SUBMITTAL REVIEW

Vermont Agency of Transportation
RECEIVED
 ON: May 10, 2016
 and Checked for
CONFORMANCE
 BY: Mark Sargent DATE: 05/13/2016

PAUL STEGLER P.E. P.E. LICENSE NUMBER 107795 A2B ENGINEERING, LLC. 5406 N. HOOVER BLVD., SUITE 12 TAMPA, FL 33634	MONOKO, LLC. 1037 PENINSULA AVENUE TARPON SPRINGS, FL 34689 PHONE (727) 940-3244 FAX (727) 279-8795	DRAWN BY: BDN 11/15 CHECKED BY: PDS 11/15 DESIGNED BY: MAT 11/15 CHECKED BY: PRS 11/15	VERMONT AGENCY OF TRANSPORTATION ROAD NO. COUNTY PROJECT ID BENNINGTON RUTLAND BF BPNT (116)	SHEET TITLE: CONTAINMENT MISCELLANEOUS DETAILS (2 OF 4) PROJECT NAME: FIVE BRIDGES ON OR OVER US ROUTE 7	REF. DWG. NO. SHEET NO. C-15
---	--	---	--	---	------------------------------------

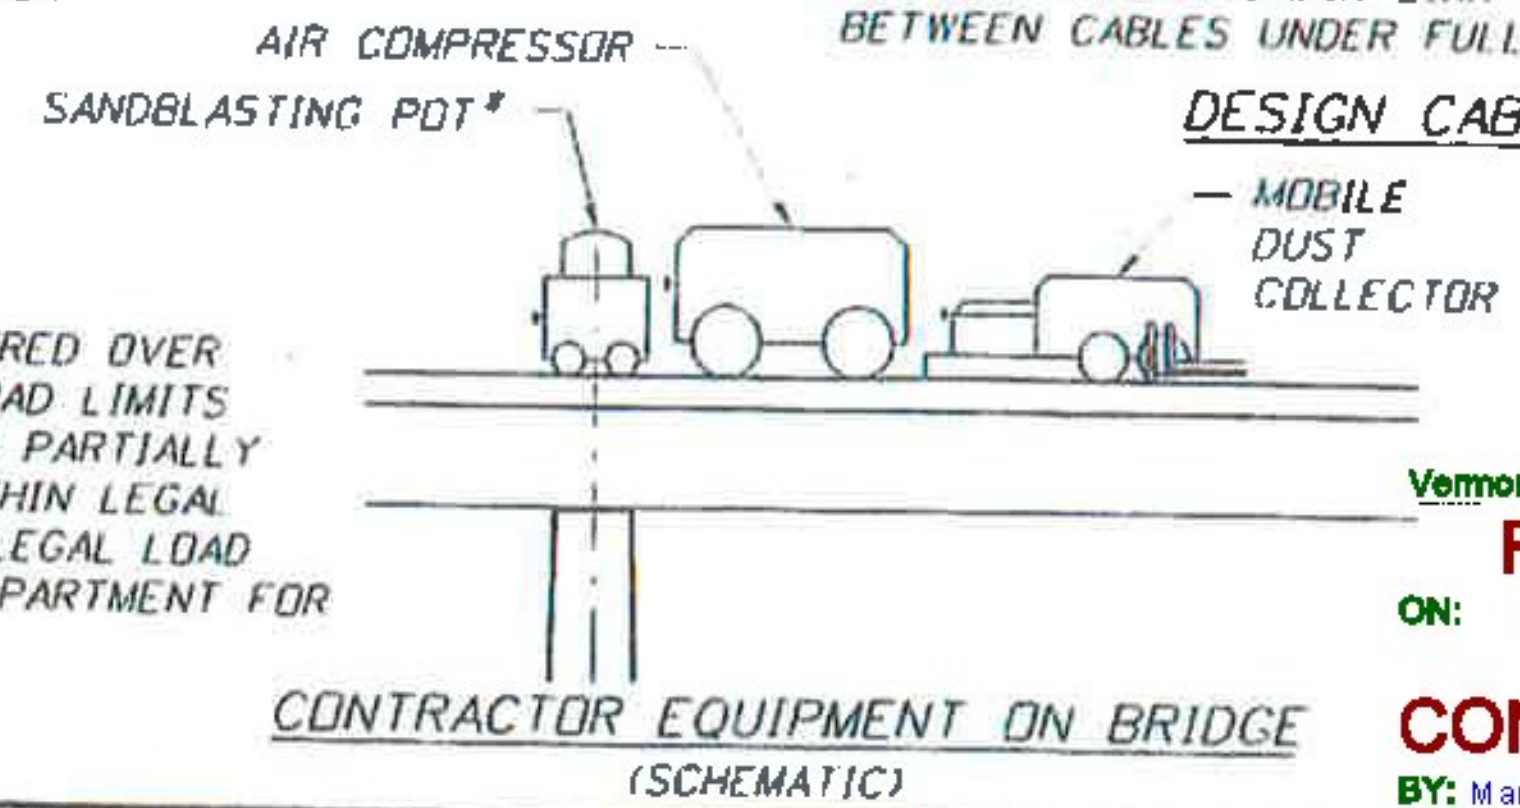
* SANDBLASTING POT SHALL BE CENTERED OVER PIER. IF EQUIPMENT EXCEEDS LEGAL LOAD LIMITS WHEN FULL, EQUIPMENT SHALL BE USED PARTIALLY FULL ONLY AS REQUIRED TO STAY WITHIN LEGAL LOAD LIMITS. ANY LOAD THAT EXCEEDS LEGAL LOAD LIMIT SHALL BE SUBMITTED TO THE DEPARTMENT FOR REVIEW AND APPROVAL.
